Ordinance: ORD-0056-2022

AN ORDINANCE TO AMEND THE OFFICIAL ZONING MAP OF THE CITY OF GAHANNA ADOPTED BY ORDINANCE 198-96 ON NOVEMBER 19, 1996, AND SUBSEQUENTLY AMENDED; CHANGING THE ZONING DISTRICT OF 13.96 +/- ACRE PARCEL LOCATED AT 5503 MORSE ROAD, PARCEL ID 025-011219 FROM ESTATE RESIDENTIAL-1 (ER-1) TO MULTI-FAMILY RESIDENTIAL DISTRICT (MFRD); PROJECT MORSE ROAD 14, SCOTT HARPER, APPLICANT

Re: Resubmission for Morse Road Multi-Family Development

RE: Morse Road Apartments | Feasibility Study

CONCEPT PLAN
MORSE ROAD
 S03

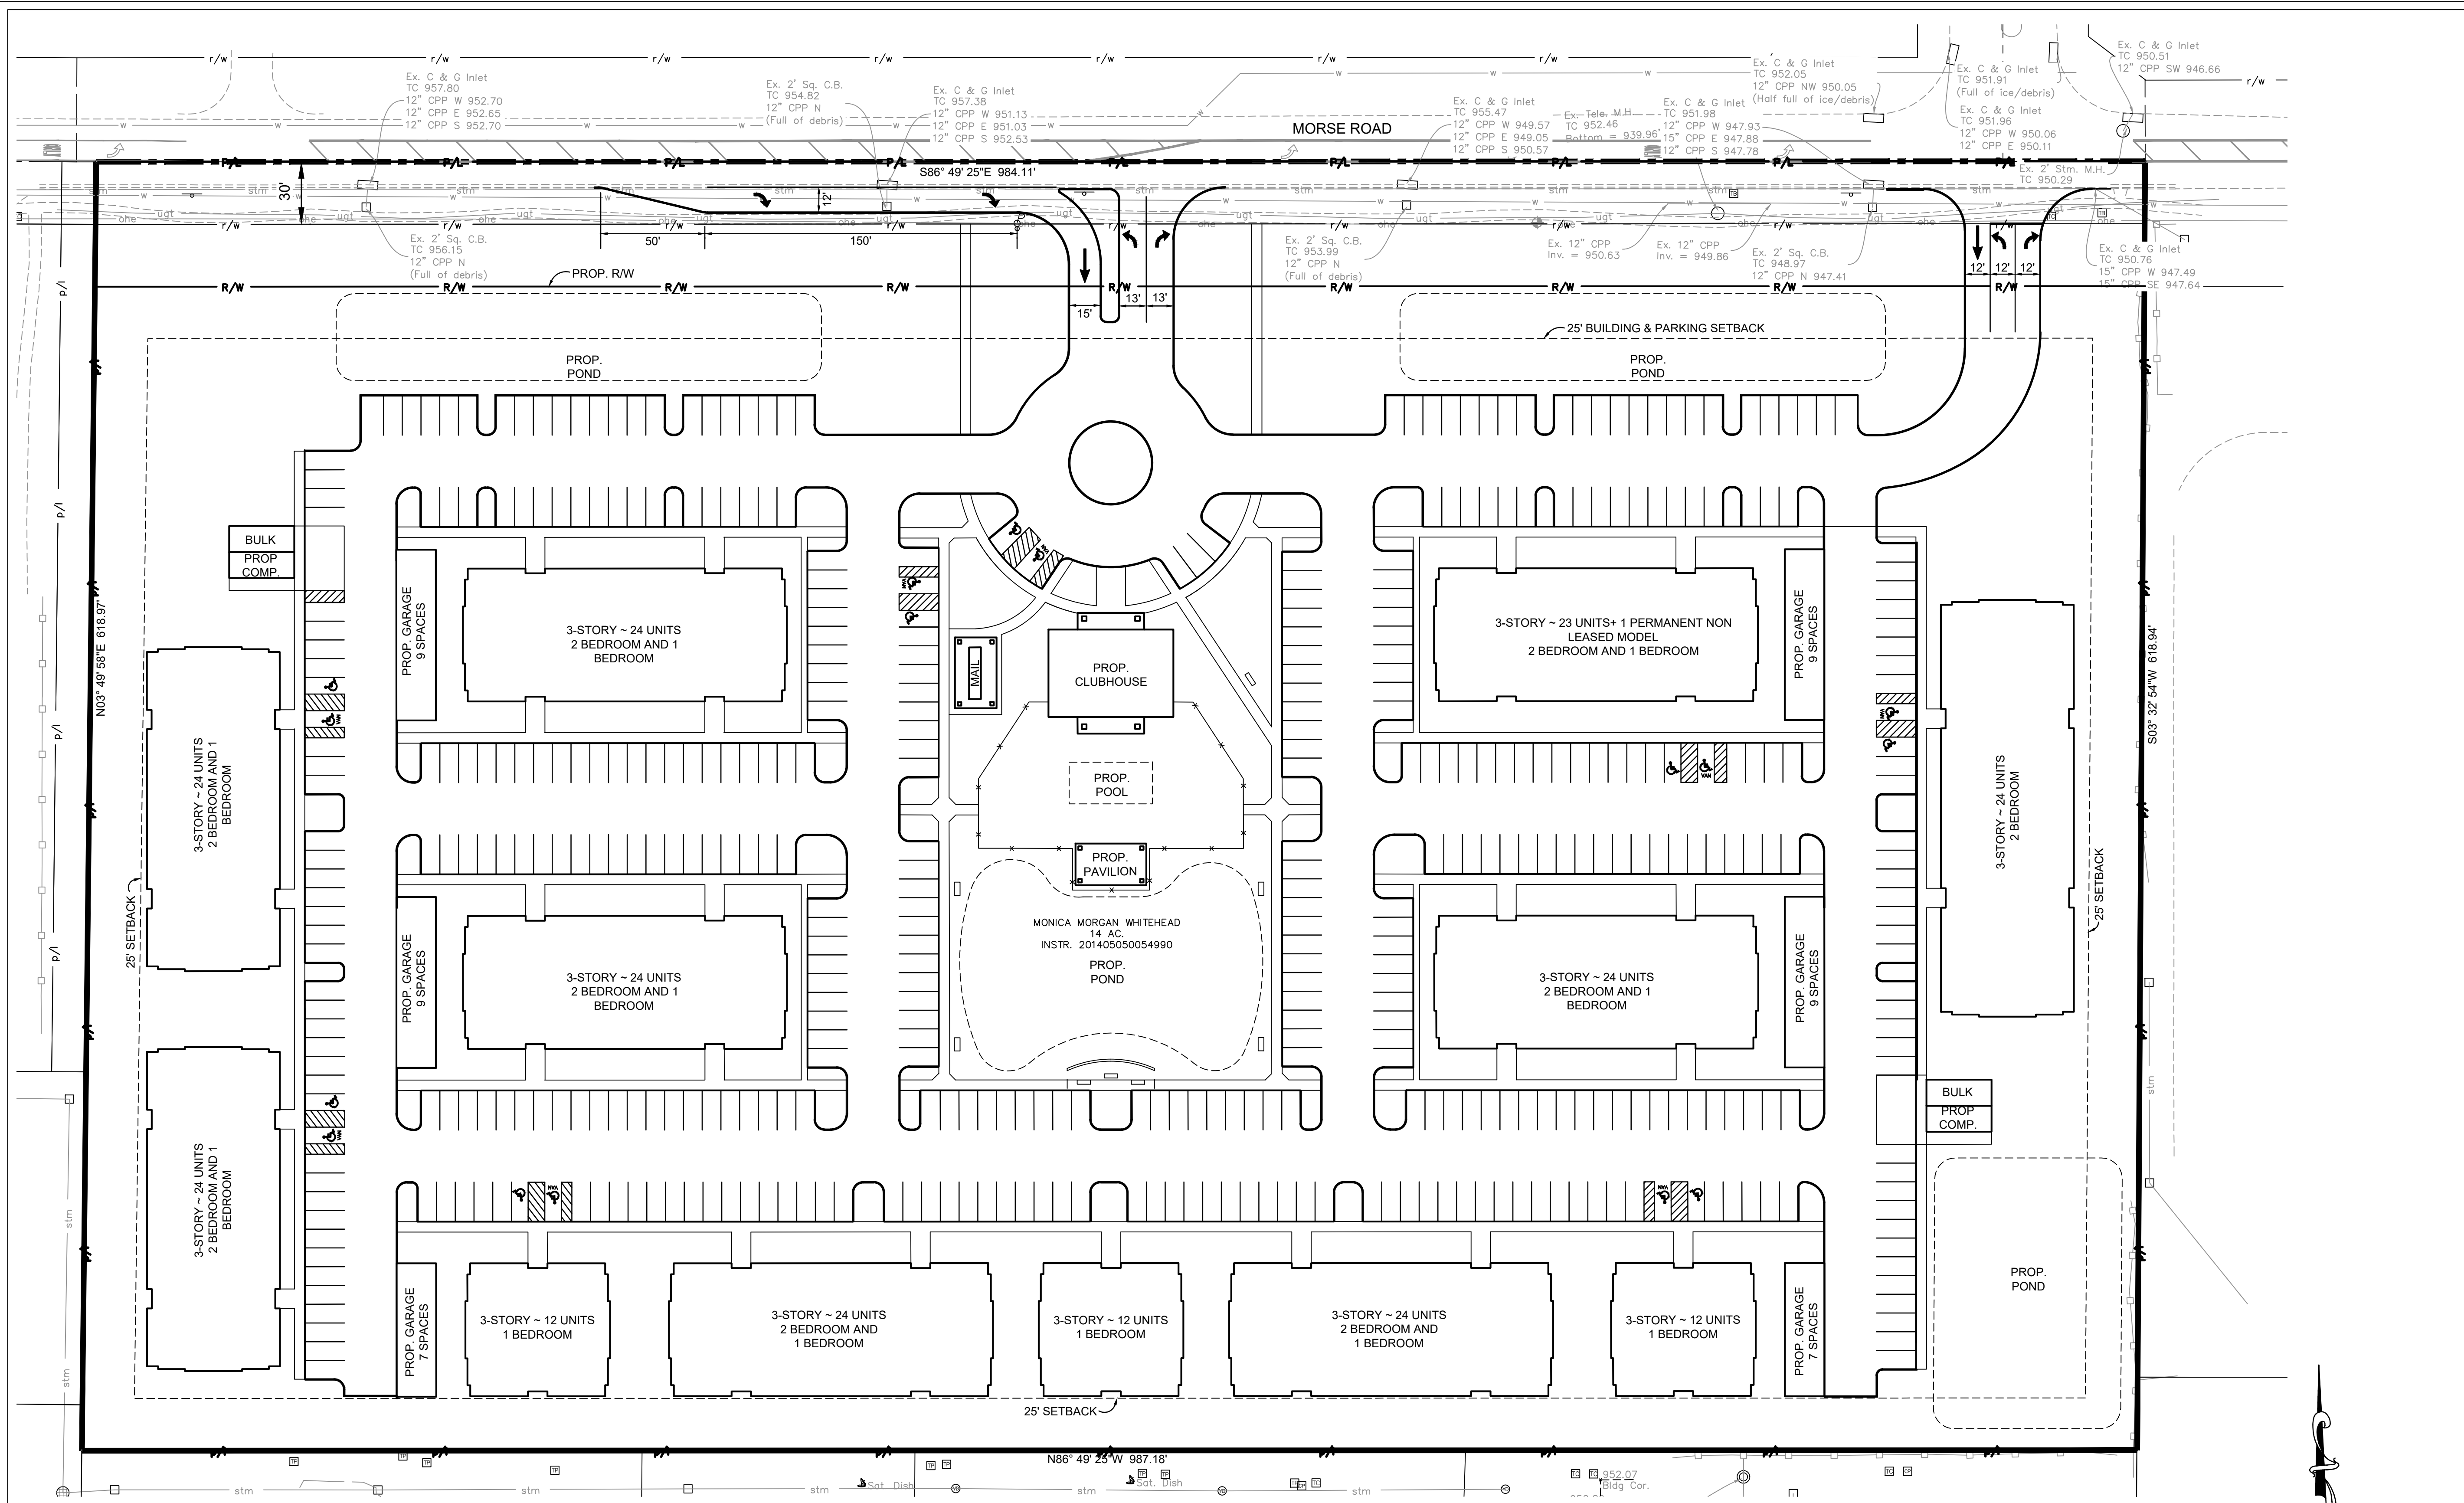
The following comments were generated from the review of the submitted plans and documents for the referenced project.

2. Informational Comment - Please be aware that the site plan review is informational as part of the rezoning review. If the rezoning is successful, then additional applications such as a final development plan (FDP) and design review (DR) application will be required prior to any tree removal/site clearing/etc.

3. Informational Comment - Chapter 1149.03(j) requires a minimum of 15% of the site to be usable open space. Open space may include pool and clubhouse areas but does not include buffers. Compliance with this requirement will be reviewed as part of the FDP submittal.

4. Informational Comment - Please be aware that buffers will be required along the east, south, and west property lines. Please review Chapters 1149.03 and 1167.20 buffer and landscaping requirements. Compliance with these requirements will be reviewed as part of the FDP and DR submittals.

5. Informational Comment - Chapter 1149.03(i) requires a minimum unit size of 700 square feet for one bedroom apartments. Compliance with this requirement will be reviewed as part of the FDP submittal.

7. The feasibility of Roadway Infrastructure to serve this project will be further reviewed as part of a Final Development Plan application. Gahanna is currently coordinating a review of the provided Traffic Impact Study with the City of Columbus, who shares jurisdiction over Morse Road. Results of that joint review will be provided once available.
(Informational Comment)

8. An existing 10" sanitary sewer was extended to the southern border of this parcel to provide sewer service. While the MRFD zoning district is consistent with the land uses envisioned by the designers of that sewer, the applicant will need to submit calculations demonstrating this sewer has capacity to service the development at the proposed density as part of the Final Development Plan application.
(Informational Comment)

Our site plan has been revised to show a total of 251 units which is within the permitted density of 18 units per acre. Please note that the developer will have one non leasable permanent model that will be located close to the clubhouse and leasing office. Please disregard our previous site plan submissions and review only the attached site plan which is dated June 9, 2022.

The site plan has also been revised to respond to the engineering review regarding the required 60' dedication corridor along Morse Road. This is consistent with the City of Columbus Multimodal Thoroughfare Plan.

3. *Informational Comment* - The setback of 25'-0" is noted. The setback shown on the revised site plan is 25'-0" from the newly required right of way. From the City engineering comments a new right of way dedication will be required with 60'-0" from the centerline of Morse Road.
4. *Informational Comment* - The applicant is aware that additional applications and a final development plan, and design review application will be required upon the successful rezoning on the property.

9. Please note that any previously submitted site plans are void. Please use the site plan included with this letter and submission. Please see the attached site plan dated 6/9/22.

10. Please reference the herein attached revised site plan for the development. The total proposed number of units is now (251) with (1) permanent non leasable model. This is within the density permitted of 18 units per acre. Please also note that the total number of parking spaces now provides a minimum of 2 parking spaces per dwelling unit.
